Re: Case No. ENV-2020-1512-EIR

Harvard-Westlake River Park Project

Co-Founder
Angeles for Trees

Figure 1 – Reasonable Project Alternative and Reduced Intensity Project Alternative to Preserve Existing Significant Tree Canopy

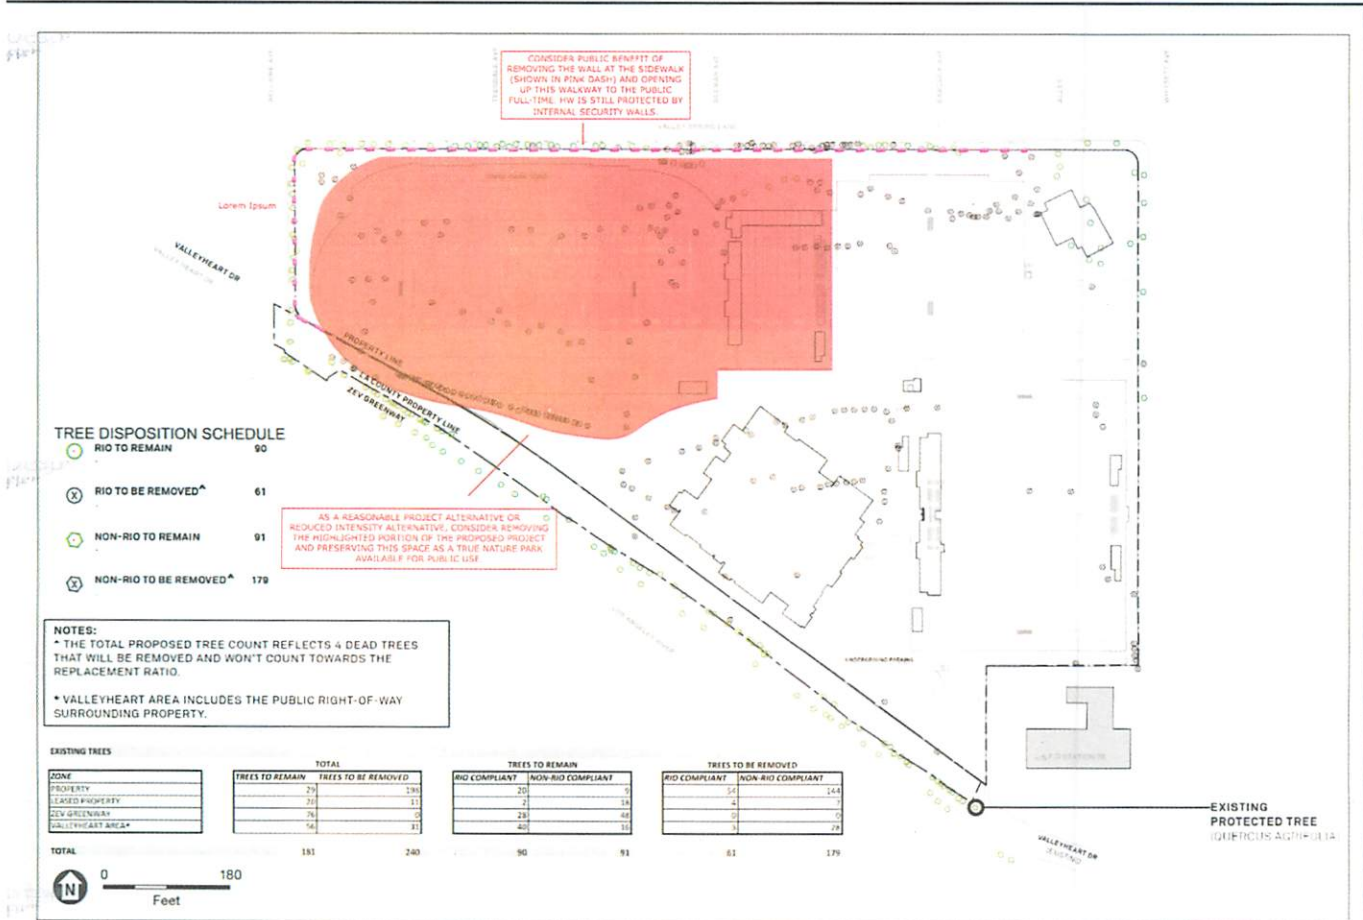
10. Native birds and native habitat need true green open space, and a Reasonable Project Alternative or Reduced Intensity Project Alternative (see Figure 1 below) can help create a true nature park that can be enjoyed by all residents and community members.

The tall wall proposed along the northern and western edges of the Project Site should be removed, so the site is open to the public. The Applicant has a secondary, interior security wall that protects its students within its sports complex. In addition, Field B and the pool should be removed. Field B is a practice field and not even configured optimally for play, as it faces east-west, which produces user glare and suboptimal lighting conditions. Across all of its campuses, Field B would also be the Applicant's fourth athletic field and the pool would be its third pool. Instead, if Field B and the pool were removed, this space would provide both the green space needed to create a true park for public enjoyment and the open space required by flora and fauna, while saving a significant number of mature trees. More specifically, if Field B and the pool were removed from the proposed Project and the land was instead preserved as green open space, the destruction of just over 100 existing significant trees would be avoided. Down the road, as these mature trees near the end of their life cycles, they could be replaced with native trees, which could help begin a transition to native understory. Finally, the preservation of a portion of the Project Site (highlighted in red in Figure 1) would help to offset some of the significant impacts of destruction to the environment the proposed Project would cause.

Figure 2- Existing General Plan Land Use which identifies the Project Site As Open Space

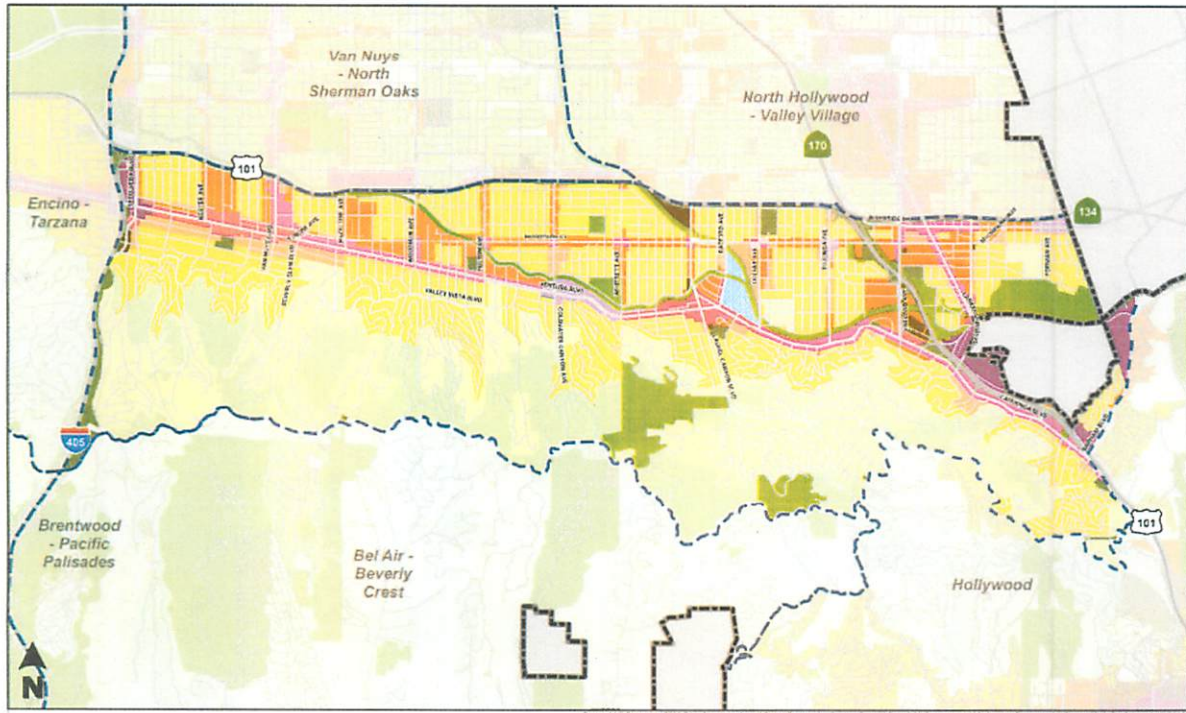
The applicant maintains that the Project Site is in the Open Space Zone (Zone O-S). This is incorrect the Project Site is in located within the A1-1XL-RIO zone, not the Open Space Zone.

The Project Site however is considered open space in the Land Use Designation. Below is a map of the General Plan Land Use in the Sherman Oaks, Studio City, Toluca Lake, Cahuenga Pass Community plan area. (see Figure 2)
